H-1-BB-MEE-1878

Hope Creek 'B' Recirculation Pump
Vibration Analysis

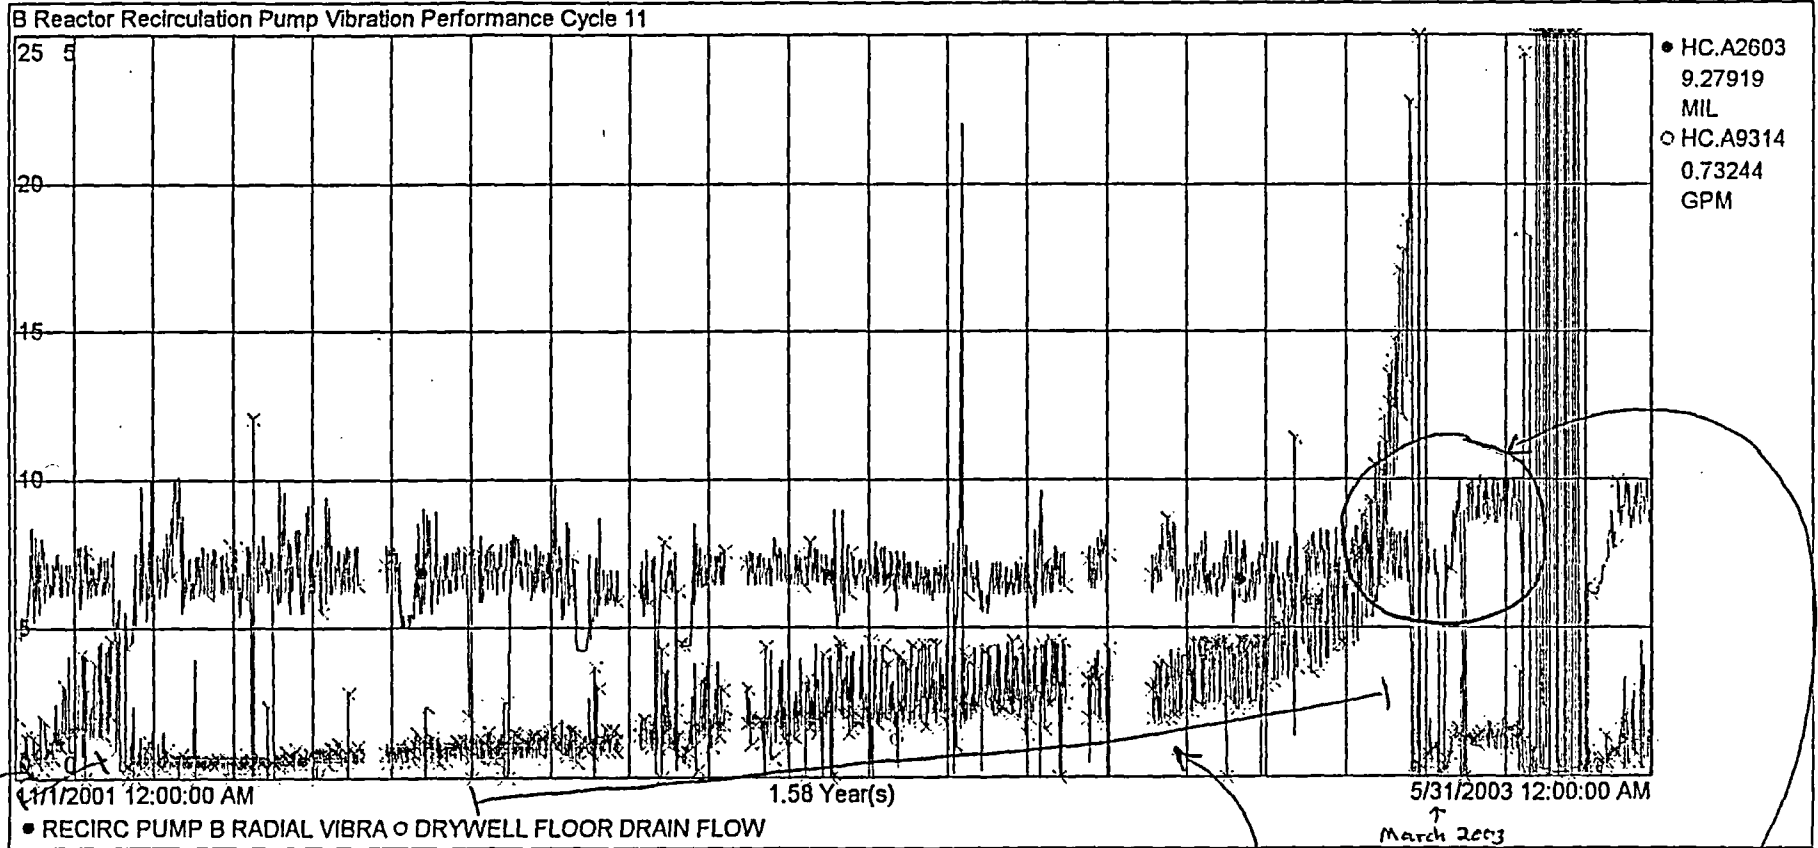
outage RFI
 Replace Mech No Pump
 Seal work
